RESUBMITTAL 7-27-84: CHANGED SITE PLAN, ACCESS DRIVE, CORRESPONDING GRADES

DRAINAGE / GRADING PLAN
FOREMAN MEDICAL PLAZA
2509 VIRGINIA N.E.

H19/D19

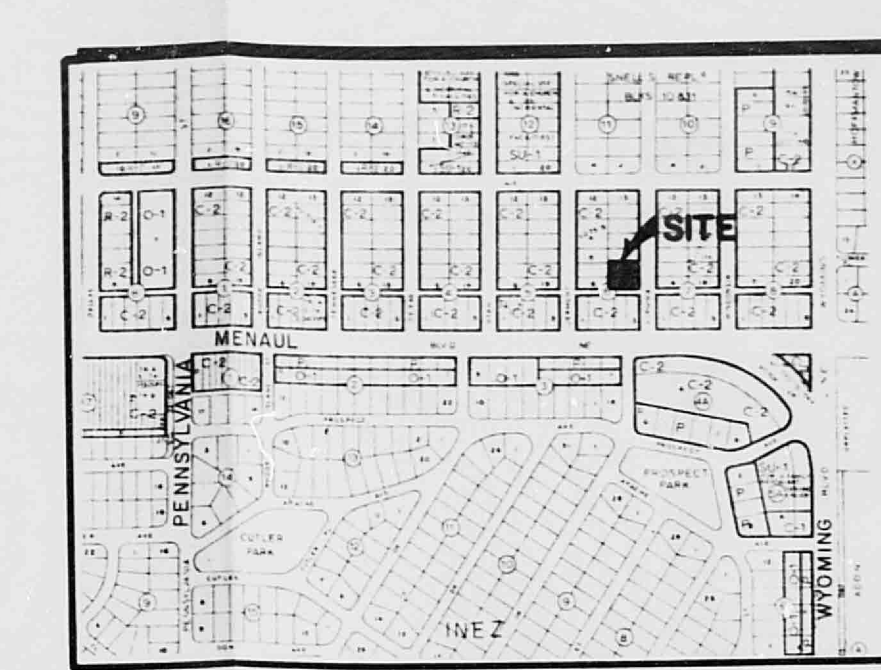
Approved
7-30-84
Revised flows into Alley
to flows into pond.
Paula Monty
